DOCKET ITEM #7

Special Use Permit #2011-0063
3310 Holly Street

Application	General Data	
Consideration of a request to construct a single-family dwelling on a substandard lot.	Planning Commission Hearing:	December 6, 2011
	City Council Hearing:	December 17, 2011
Address: 3310 Holly Street	Zone:	R-8 / Single-Family Residential
Applicant: Alabama Ave LC, represented by Steve Kulinski, architect	Small Area Plan:	Potomac West

1
A3 **PROPOSED PLAN**
SCALE: 1/16" = 1'-0"

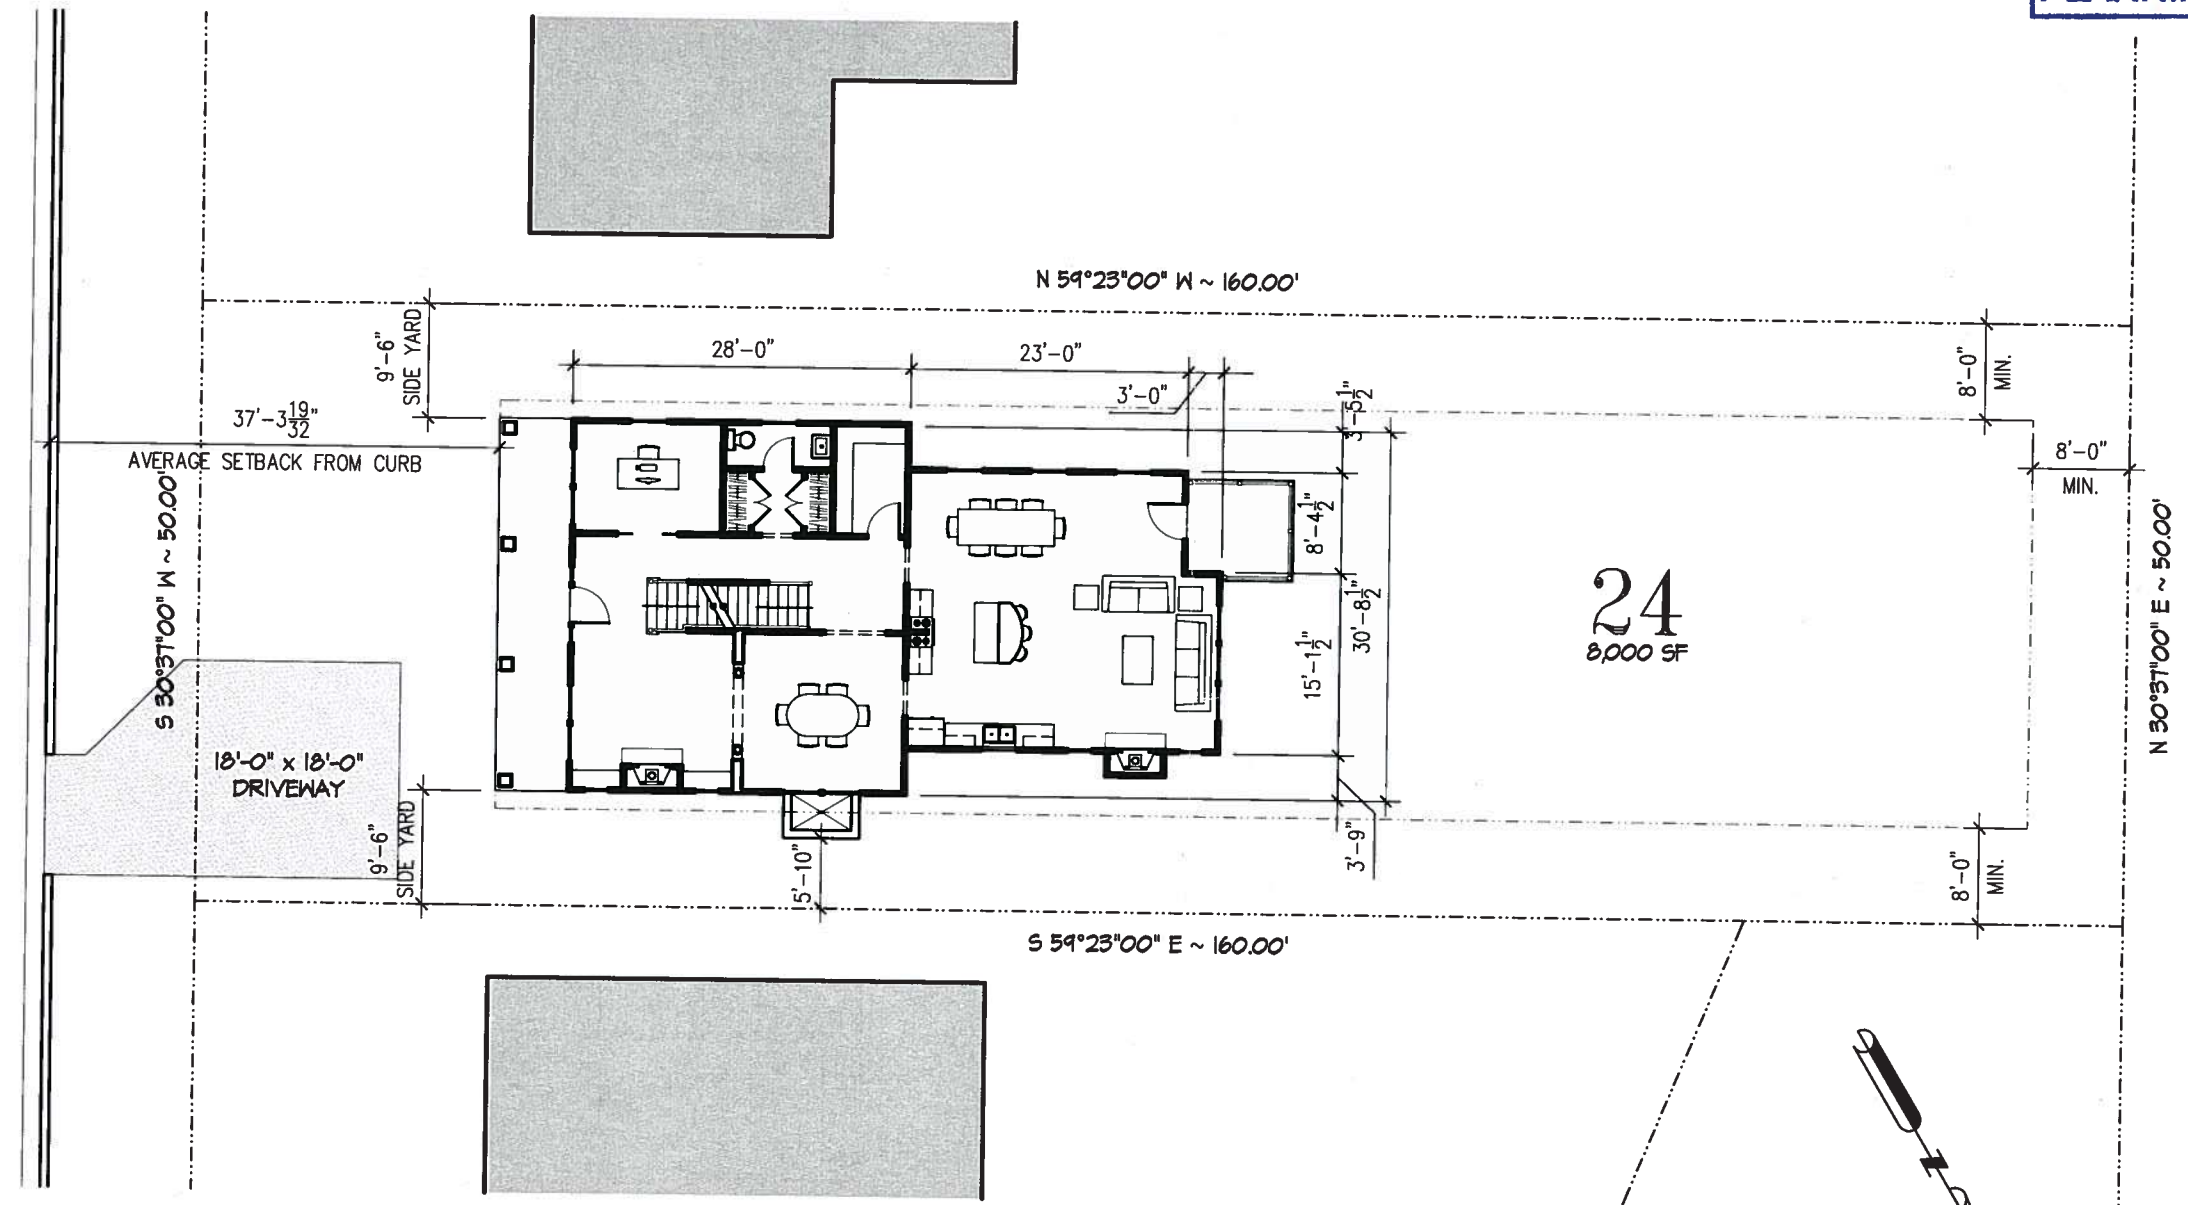
On the other hand, staff does not support the applicant's request for side yard modifications, finding them neither necessary nor desirable in order to develop the lot. Although small side yards, some as small as 4.5 or five feet, are present at several properties in the immediate area, the repetition of reduced-size side yards here is not necessary to develop the lot. The applicant can, despite the significant grade change noted as the justification for the modification, easily narrow the width of the house by 1.25 feet on each side, or 2.5 feet in total, and meet the Zoning Ordinance requirement. Staff also finds that the modifications are not desirable here. The required 10.75-foot side yards will not make the building appear out of place given that a variety of side yard setbacks exist in the neighborhood and that the reduced dwelling width of 28.5 feet is not significantly narrower than other dwellings on the block. Staff therefore recommends in Condition #1 that the applicant shall meet required side yard setbacks.

Staff also finds the proposed double-wide driveway to be objectionable and is recommending in Condition #2 that the applicant provide two parking spaces in a driveway designed in a tandem parking arrangement that is no wider than the width of one vehicle. The proposed double-wide driveway design occupies too much of the front yard and interrupts the neighborhood pattern of either single-wide driveways or no driveways at all. Condition #2 requires the driveway to be constructed using a permeable paving system, which is a standard requirement for new single-family dwellings requiring SUPs.

Finally, staff is concerned about an especially large oak tree on the southern side of the applicant's property which the applicant claims cannot be saved. Staff is recommending in Condition #3 that the applicant plant a new, replacement tree on the lot, which requirement is in addition to the 25% tree crown coverage requirement from the Zoning Ordinance.

1. **CONDITION AMENDED BY PLANNING COMMISSION:** The design and placement of the dwelling shall be substantially consistent with the illustrations dated November 17, 2011 to the satisfaction of the Director of Planning & Zoning ~~except that the applicant shall meet the minimum side yard requirement on both sides of the proposed dwelling~~ including the modified side yard setbacks of a maximum of 9.5 feet on each side of the dwelling. (P&Z) (PC)

2. The driveway shall be constructed to accommodate two parking spaces in a tandem arrangement consistent with Zoning Ordinance requirements, shall be limited in its width to not more than 9.5 feet wide, and shall use a permeable paving system to the satisfaction of the Director of Planning & Zoning. (P&Z)

3. **CONDITION AMENDED BY PLANNING COMMISSION:** The applicant shall, ~~consistent with its representation that the oak tree could be saved, install a new tree on the southern side of the property or other appropriate location, to the satisfaction of the Director of Planning & Zoning, to replace the existing oak tree that will be removed. The subject tree shall be required in addition to the tree crown coverage requirement found in the Zoning Ordinance.~~ provide, implement and follow a tree protection program that is developed consistent with the City of Alexandria Landscape Guidelines for the large oak tree on the southern edge of the property to the satisfaction of the Director of Planning and Zoning and the City Arborist. (P&Z) (PC)
